RE: Amerada Hess Corp- Former Port Reading Refinery
EPA ID No. NJD045445483
750 Cliff Road
Woodbridge Twp, Middlesex County
PI#: 006148

Comment Letter: AOC 12: Smith Creek and Detention Basin

The New Jersey Department of Environmental Protection (Department) has completed a review of the AOC 12: Smith Creek and Detention Basin submitted July 30, 2021. The document was submitted pursuant to the Site Remediation Reform Act (N.J.S.A. 58:10C-1 et seq.), the Administrative Requirements for the Remediation of Contaminated Sites (N.J.A.C. 7:26C), and the NJDEP Technical Requirements for Site Remediation at N.J.A.C. 7:26E.

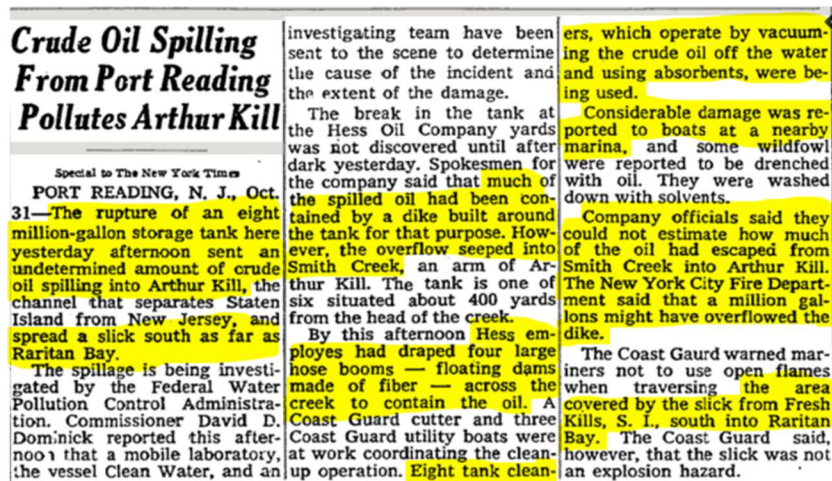
17. The Location of AOC 78 connection to the Detention Basin/Smith Creek needs to be shown:

- a. AOC 12 Smith Creek and Detention Basin: The current detention basin dimensions are approximately 800' x 600' and 5-6' in depth. Aerial photos (1957-present) showed that the current detention basin area and represented changes that began circa 1963 including: 1) restriction of the connection of on-site Smith Creek/wetland areas to off-site Smith Creek circa 1963-66; and 2) changes to facility stormwater management and treatment in conjunction with the complete separation of the site from Smith Creek after construction of the dike and Smith Creek Pond.
- b. The entire LNAPL impact area footprint needs to be considered in sampling plans:
1969 AST failure LNAPL impact areas:

Figure 1- Previous location of Smith Creek prior to 1970, the area within the red circle needs to be sampled.

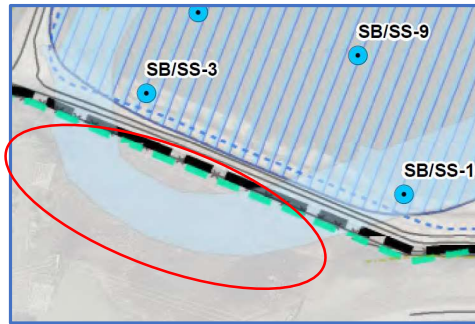
1. The figure below displays the area south of the road. Please collect a minimum of two samples where the former Smith Creek used to be.

Figure 3- Unidentified sitewide utilities. Imaged cropped from Figure 8.

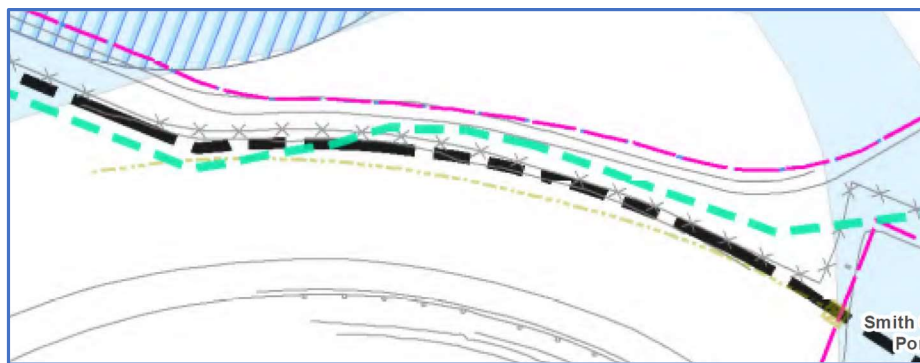
21. Please include additional information on the sitewide utility/outfall (yellow hash line). Furthermore, please provide additional information on this feature, connection, and type of discharges.
